Access Compliance Report

Public Rights-of-Way

(Curb Ramps)

Intersection ID: 48985	Main Street: AVONCLIFF_DR	Cross Street: KINGSDOWN_AV	Location: NW
ADA ID: D1A291BB60DD	Ramp Type: Perp	Initial Pass/Fail: Fail	Overall Compliance: No
Severity Score: 21.25			
Codes/Mitigation Info/Possible Solution		Field Measurements/Component Compliance

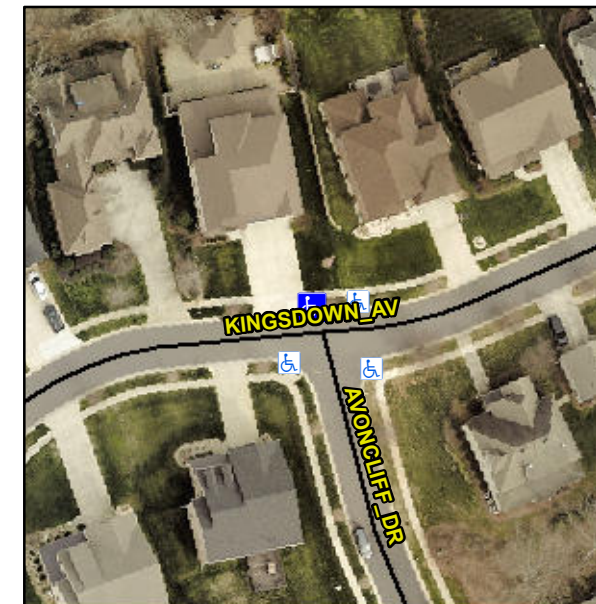
Not Found, R304.5.1, R304.5.3

Compliance	Description	Data	Compliance	Description	Data
N/A	Ramp Length (in)	71.0	Yes	Ramp Slope (%)	6.4
No	Ramp Width (in)	46.0	No	Ramp XSlope (%)	5.4
N/A	Flare Type LT	N/A	N/A	Flare Type RT	N/A
N/A	Flare Slope LT (%)	N/A	N/A	Flare Slope RT (%)	N/A
N/A	Flare Traversable LT?	N/A	N/A	Flare Traversable RT?	N/A
N/A	Landing Length (in)	N/A	N/A	DWS Provided?	N/A
N/A	Landing Width (in)	N/A	N/A	DWS Contrast?	N/A
N/A	Landing Slope (%)	N/A	N/A	DWS Length (in)	N/A
N/A	Landing X Slope (%)	N/A	N/A	DWS Full Width?	N/A
N/A	Landing Curb? (Y/N)	N/A	N/A	DWS Offset (in)	N/A
N/A	Shared Landing?	N/A			
N/A	Gutter Ponding?	N/A	N/A	Gutter Slope (%)	N/A
N/A	Gutter Lip Ht (in)	N/A	N/A	Gutter X Slope (%)	N/A
N/A	Painted X Walk1?	No	N/A	Painted X Walk2?	N/A
	X Walk 1 Direction	To SW		X Walk 2 Direction	N/A
N/A	X Walk 1 Width (in)	N/A	N/A	X Walk 2 Width (in)	N/A
	X Walk 1 Slope (%)	3.8		X Walk 2 Slope (%)	N/A
	X Walk 1 X Slope (%)	6.8		X Walk 2 X Slope (%)	N/A

Remove & Replace Entire Ramp.
